Annual Project Work Plan - Trails Form

State Park Name: Fahnestock

Trail Name: Canopus

Tread definition, minor realignments, possible crib wall

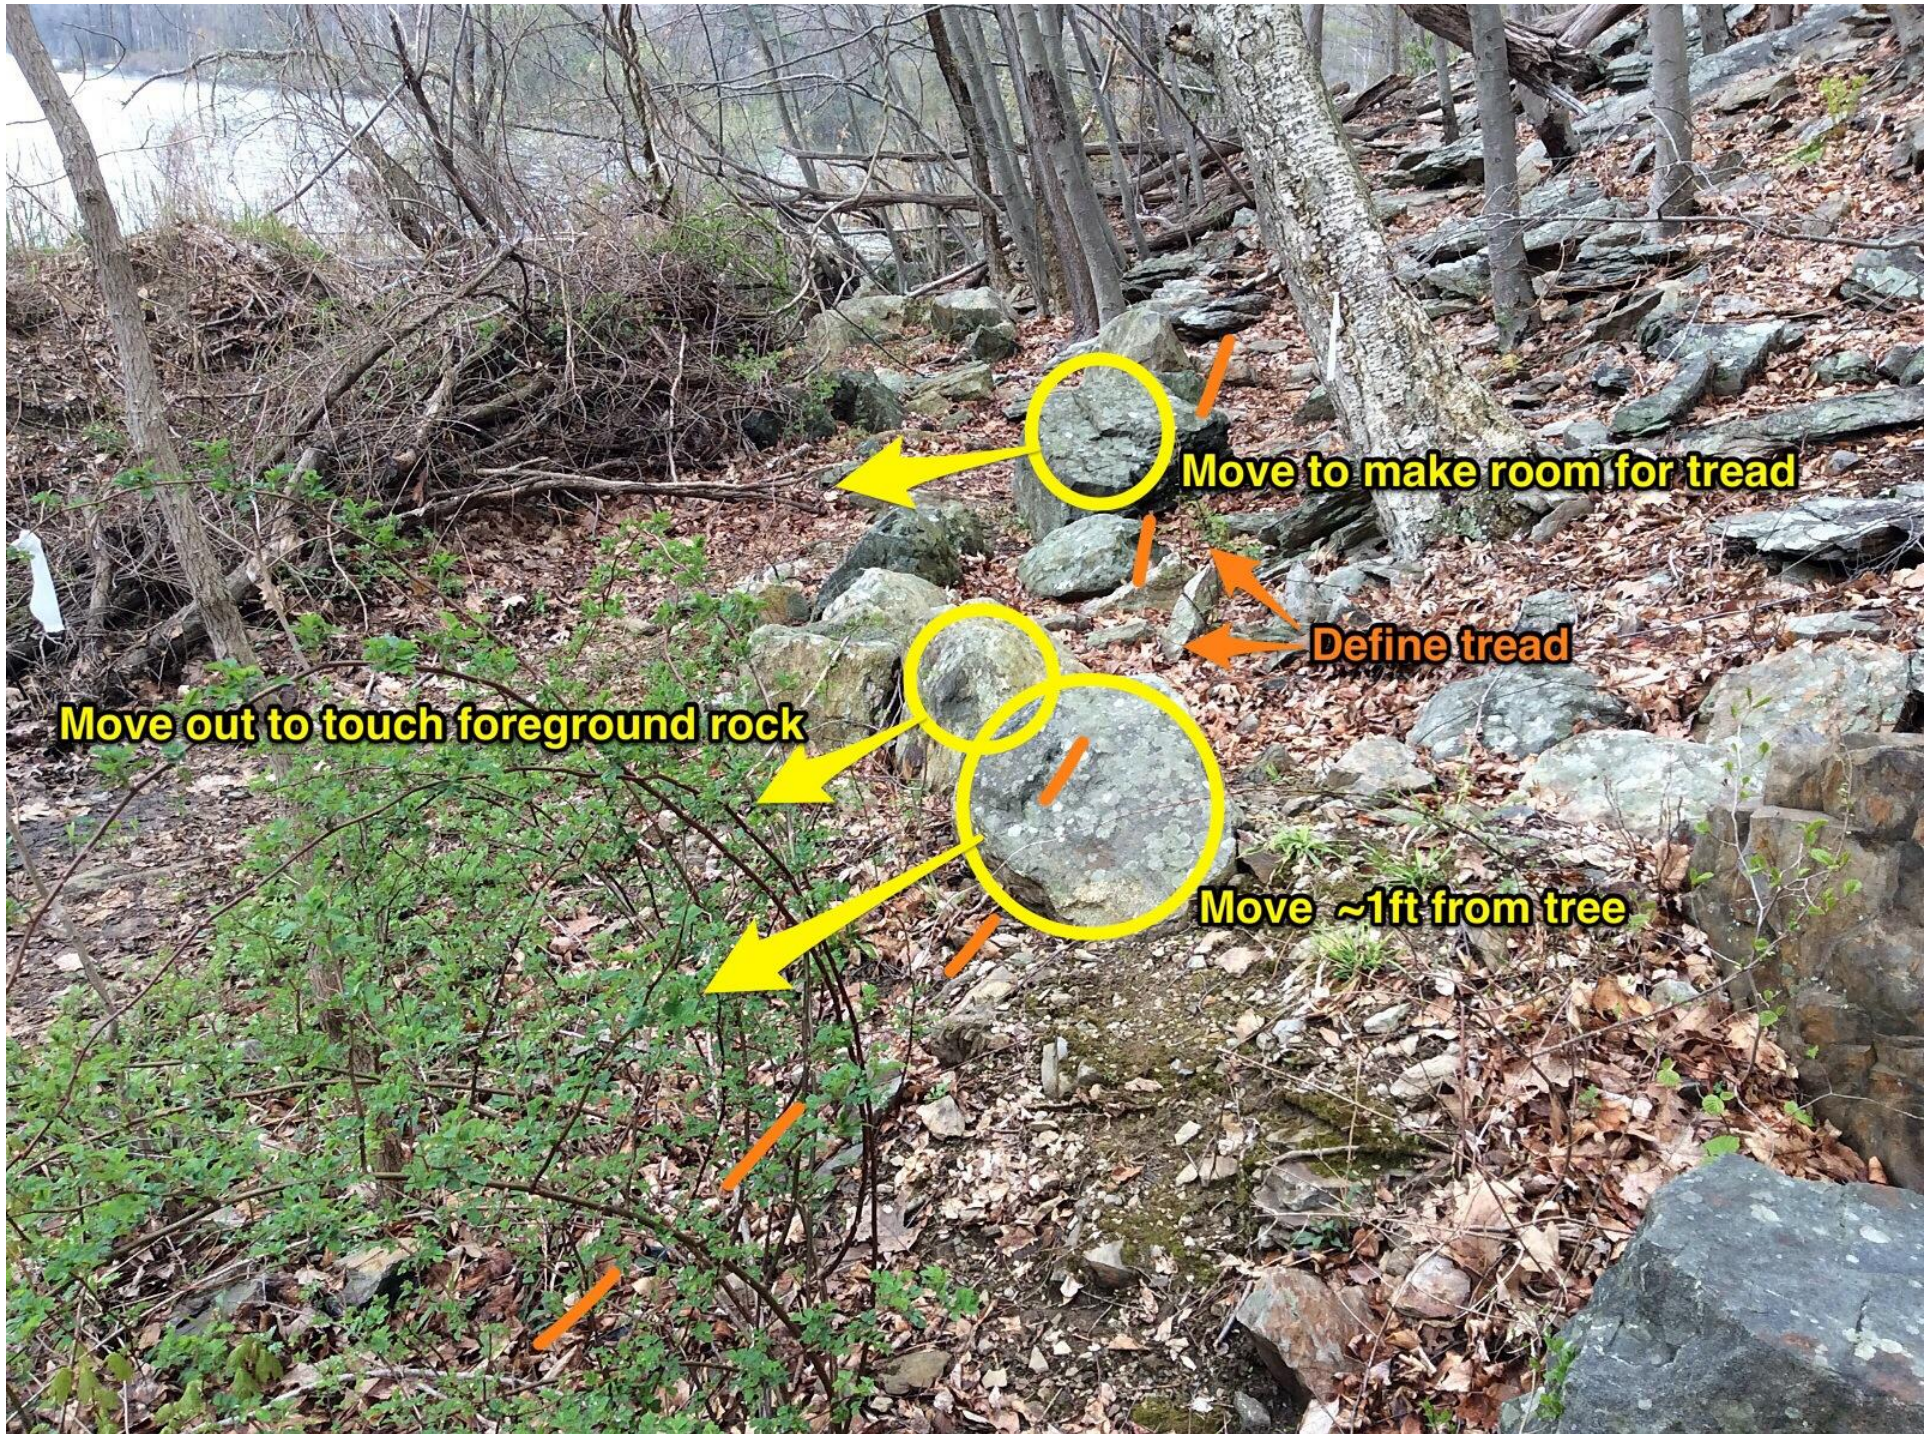
**Remove duff to expose stepping areas,
create new as needed (max 7 inch rise)**

Modified

Continue tread definition

**Expose rock
for crib evaluation**

De-duff and bench first

**Potential crib section
(see other image)**

**Define tread
and sidehill/bench**

Define tread

Remove

Define tread

Move

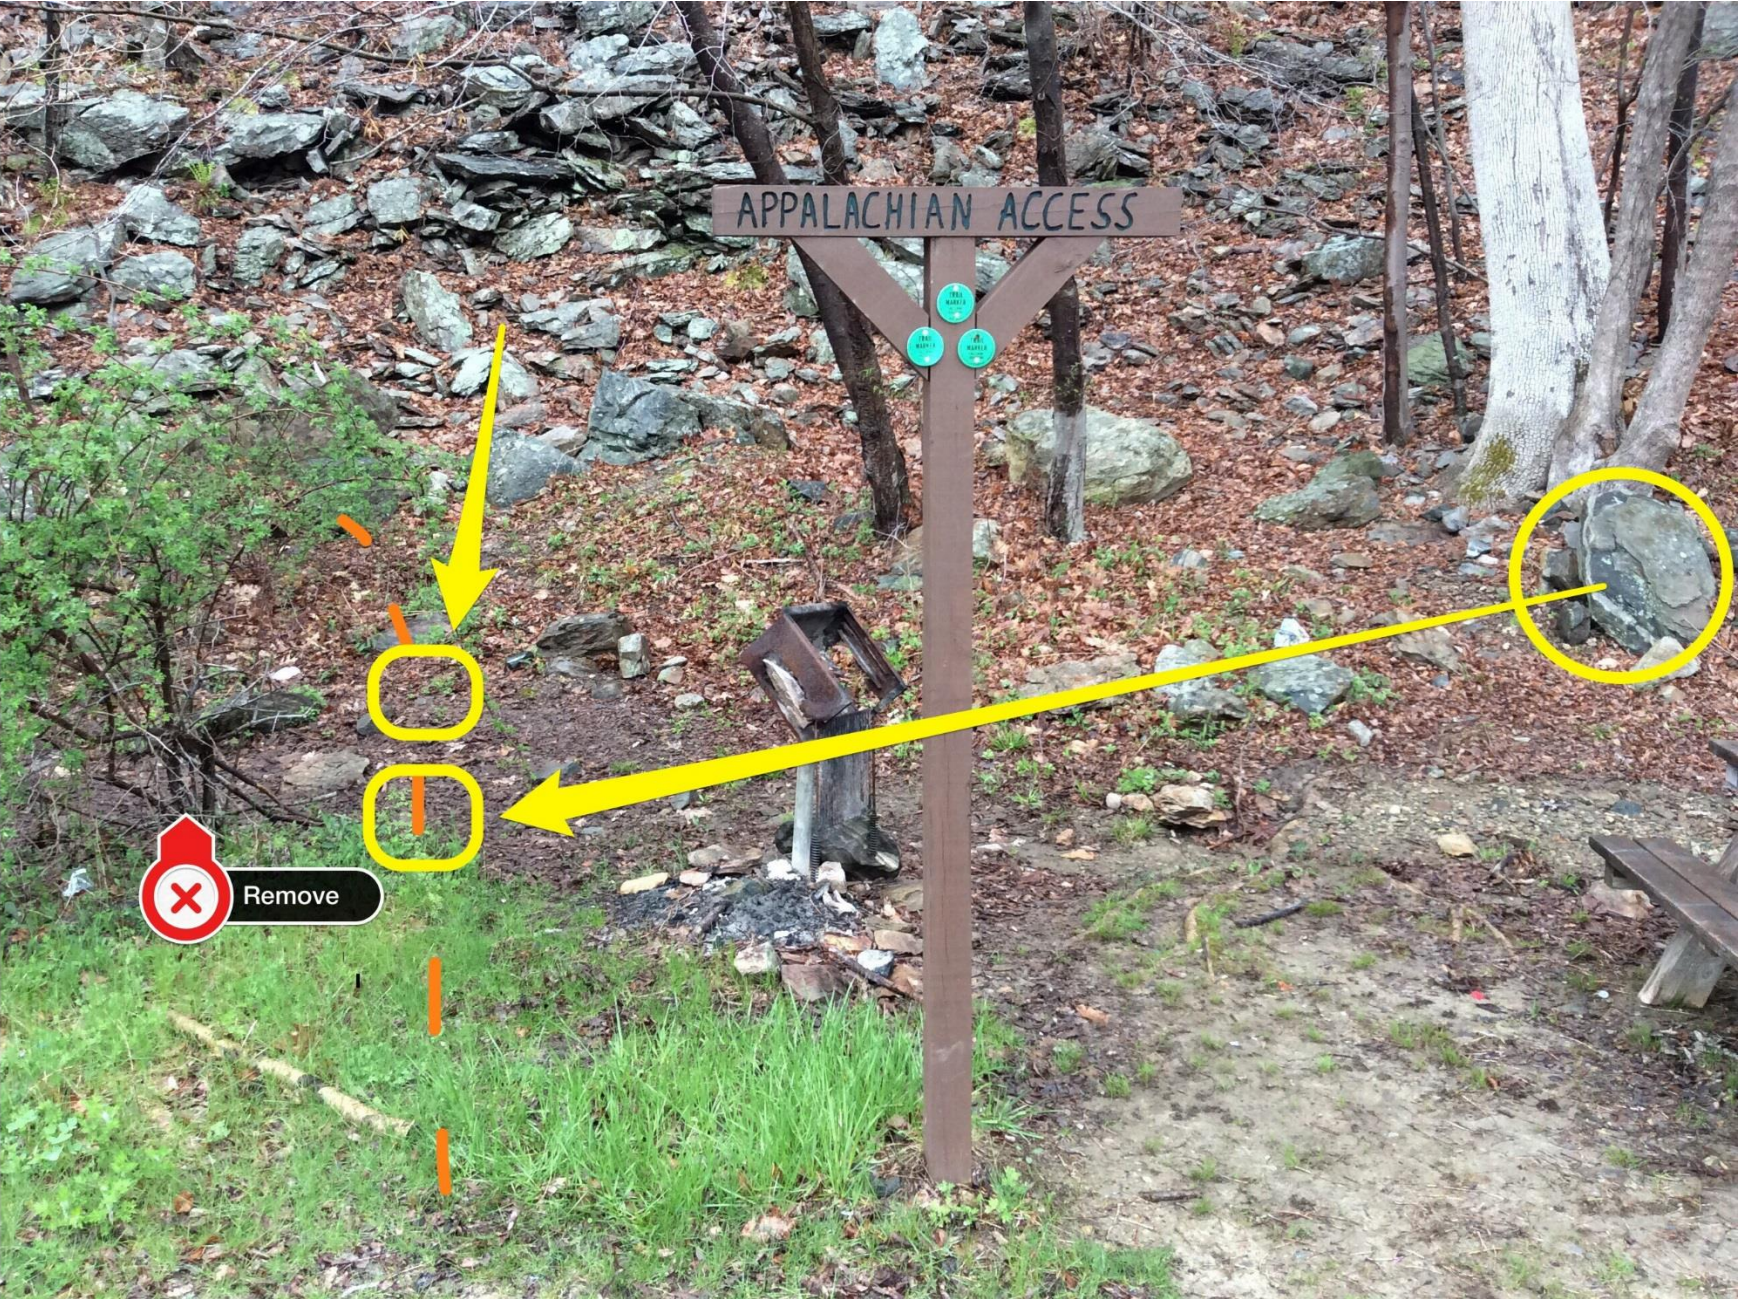
Define tread to crest

Don't move

Move to make room for tread

Define tread

Move ~1ft from tree

Move out to touch foreground rock
